ADDENDUM NO. 1**March 6, 2023**

**RE: Spencer County Public Library Annex Building
Taylorsville, KY
Project No. 22078**

**FROM: Brandstetter Carroll Inc.
2360 Chauvin Drive
Lexington, Kentucky 40517
Phone 859-268-1933
Fax 859-268-3341**

Power Plans

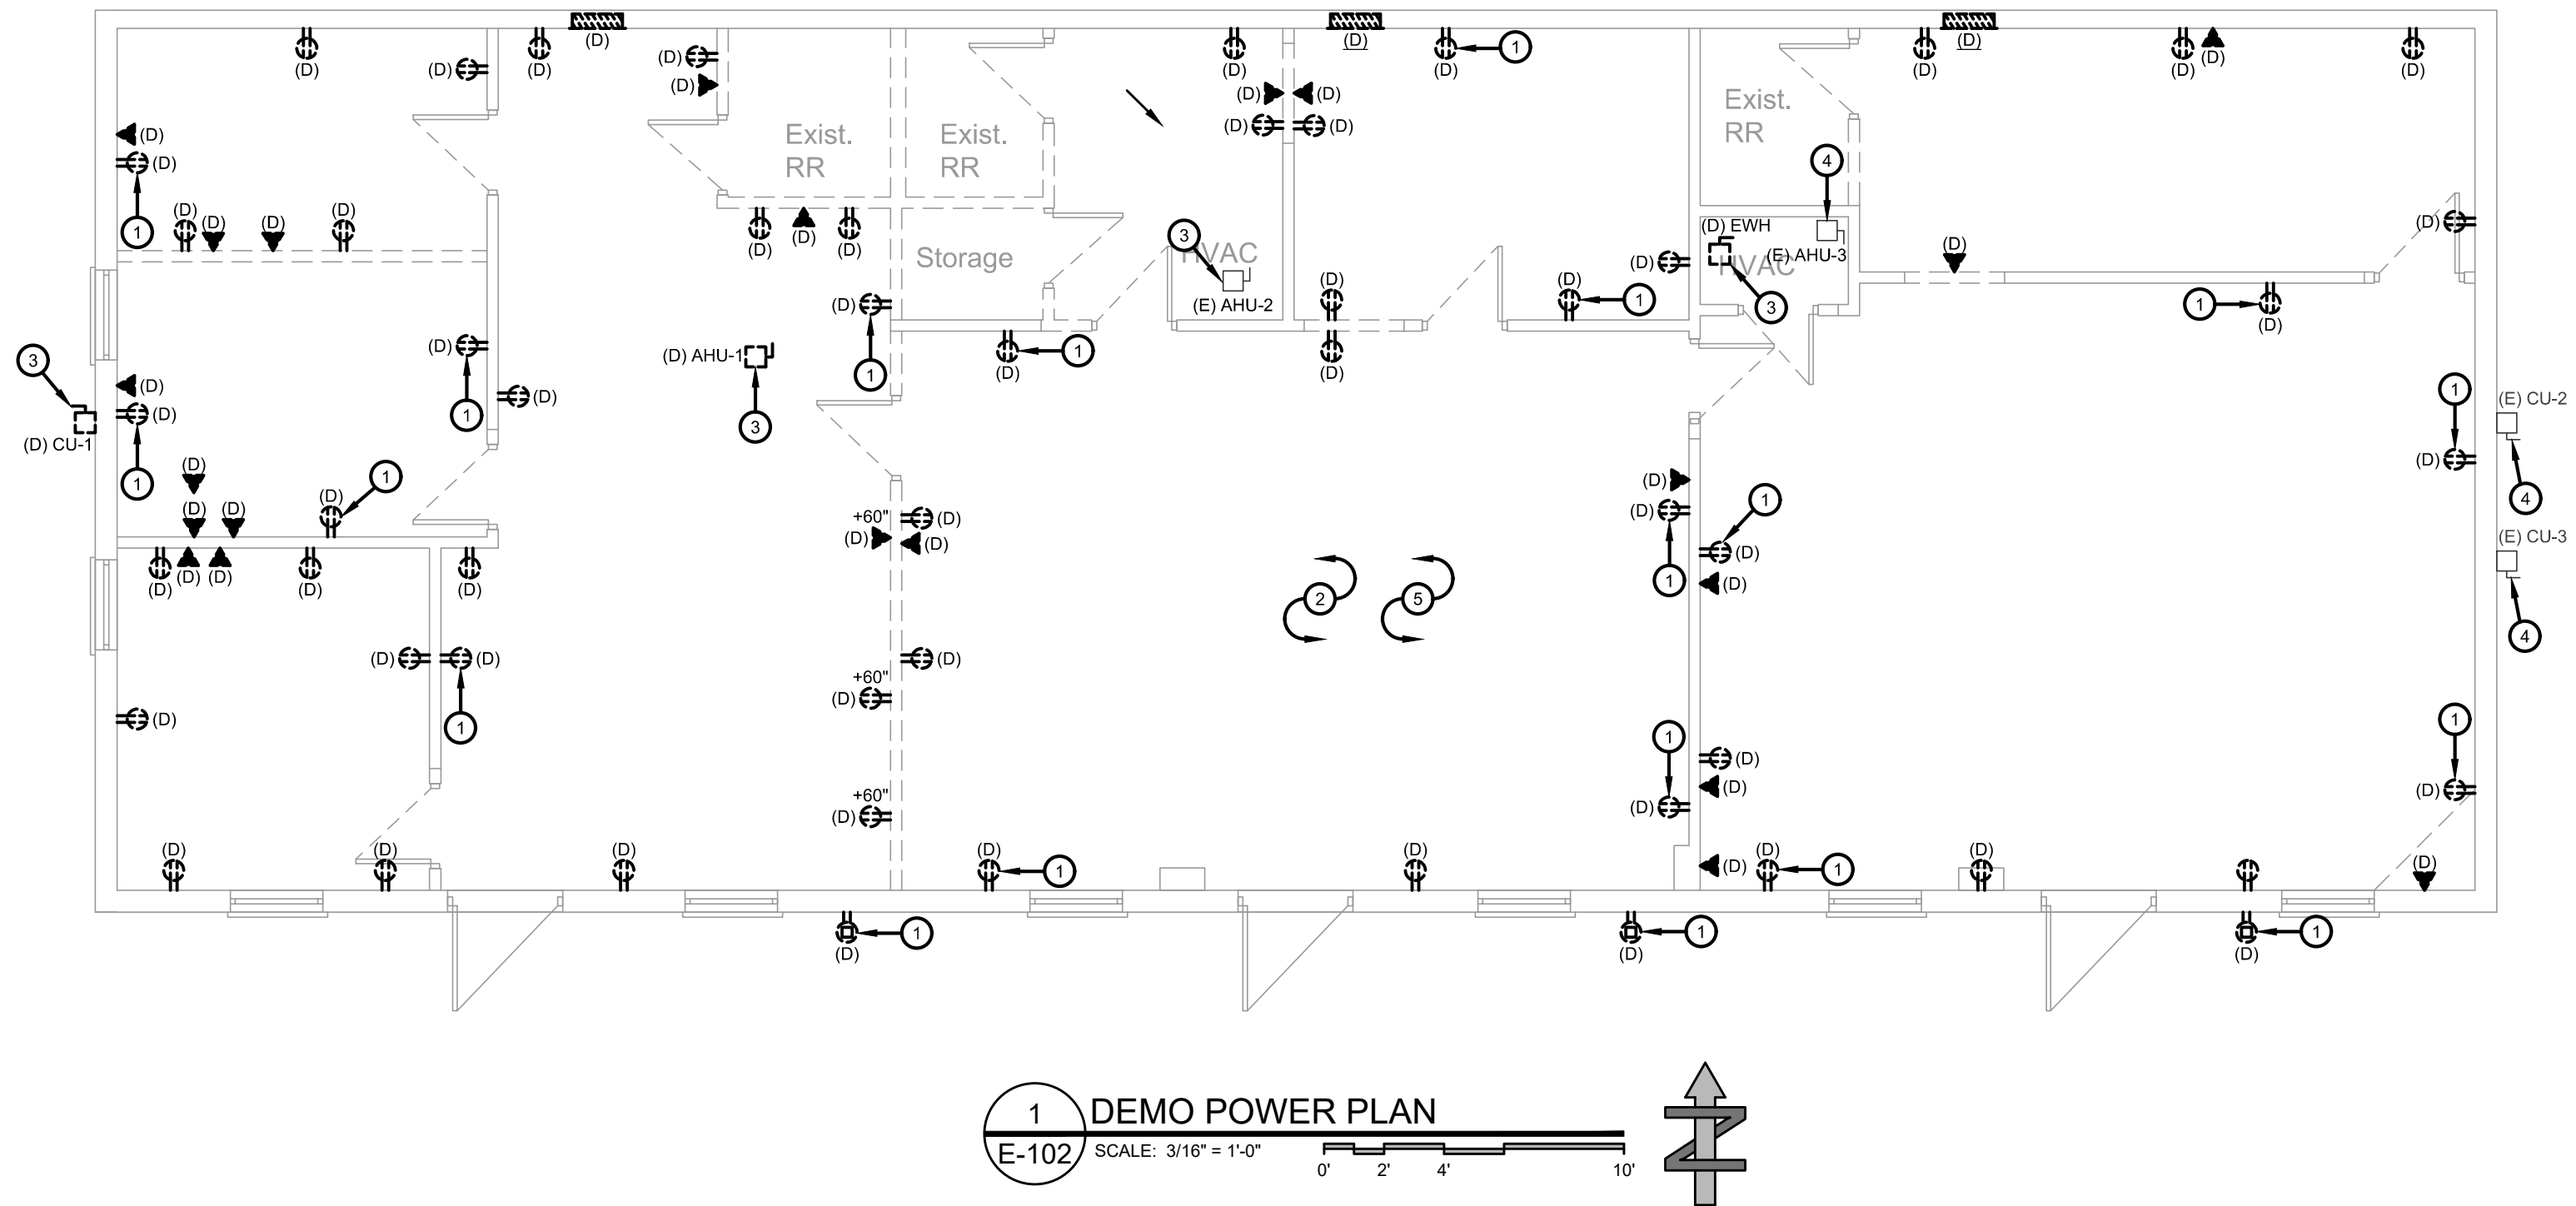
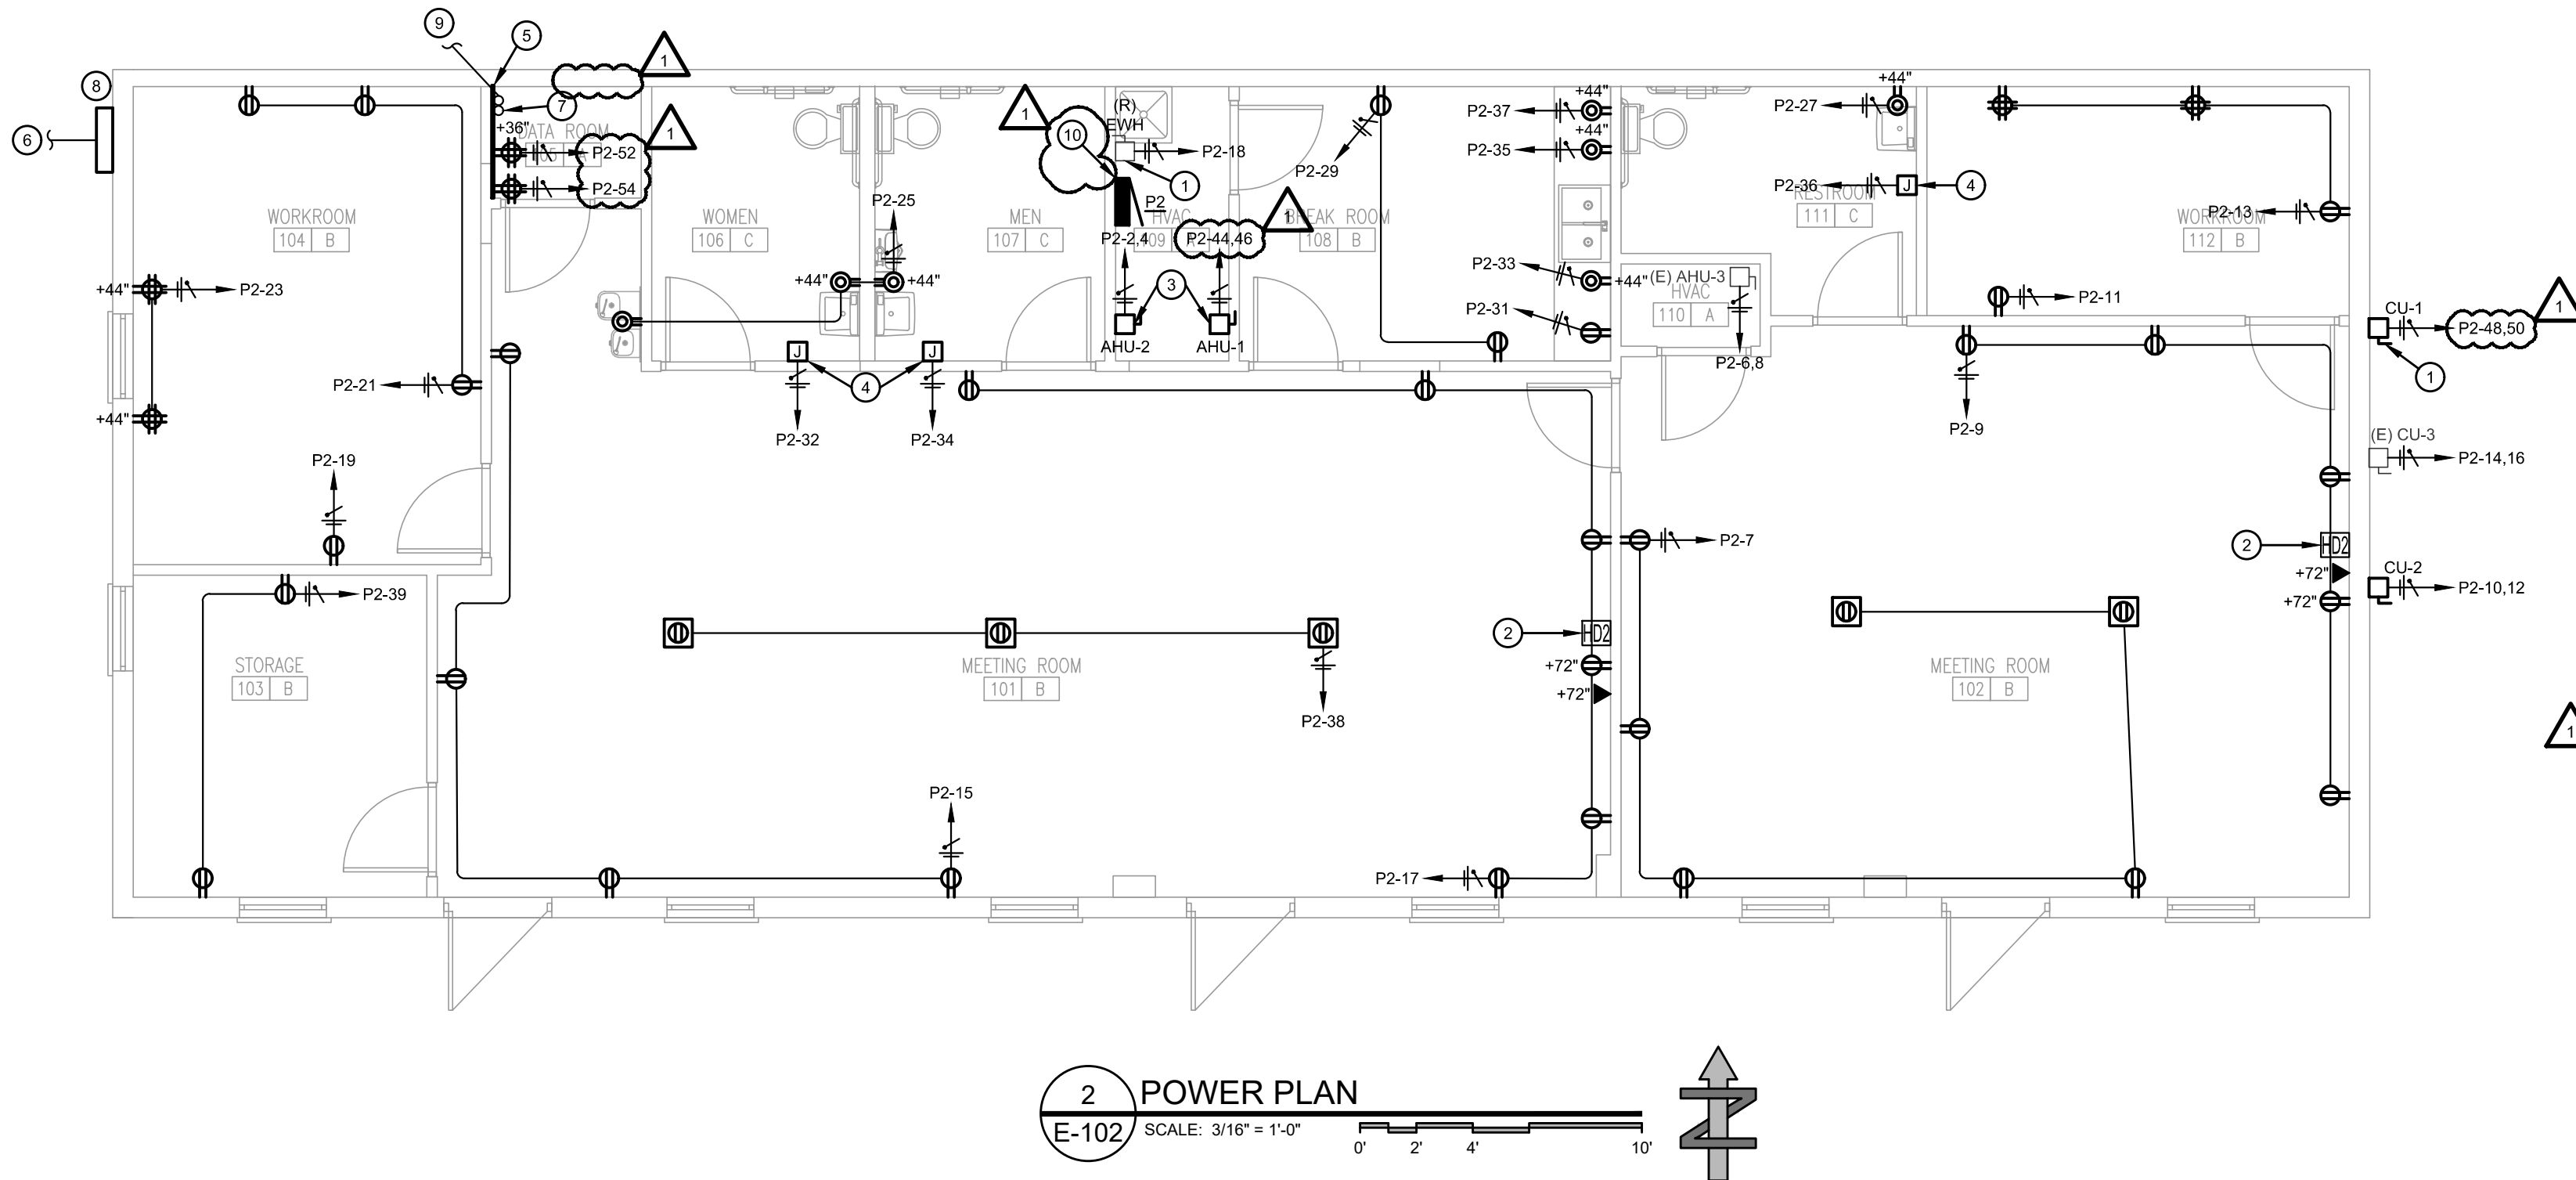
2. E-102 Power Plans
 - A. Delete in its entirety Power Plan Note 7. PVC conduits for low voltage service entrance are not required.
 - B. Delete in its entirety Power Plan Note 9. Existing telecom service will not be utilized.

- C. Delete floor boxes in their entirety in Rooms 101 and 102.
3. E-501 Electrical Schedules & Single Line
 - A. Electrical Panel P2 is to be Single Phase. Panel P2 is also to be increased to 400A, in lieu of 200A as shown.

1 DEMOLITION SINGLE LINE DIAGRAM

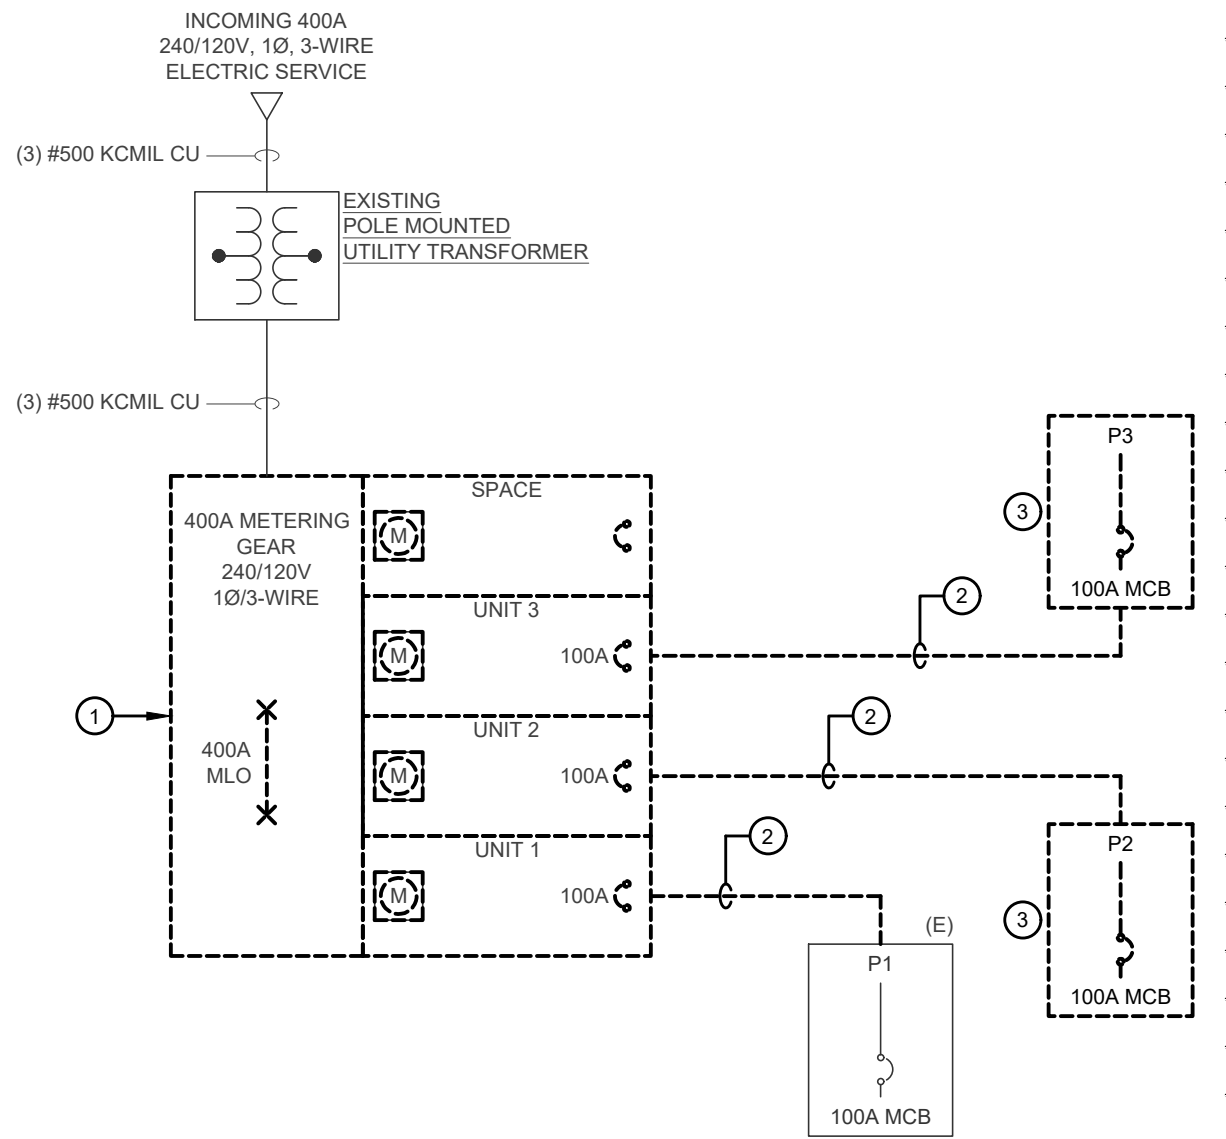
- i. The existing 4-gang meter stack to be removed and replaced with a 400A high capacity meter base and 400A fused service disconnect. A new 400A panel to be provided. The Existing panel P1 is to be removed complete. All existing circuits that are to remain are to be wired back to new panel. Refer to revised single line diagram.
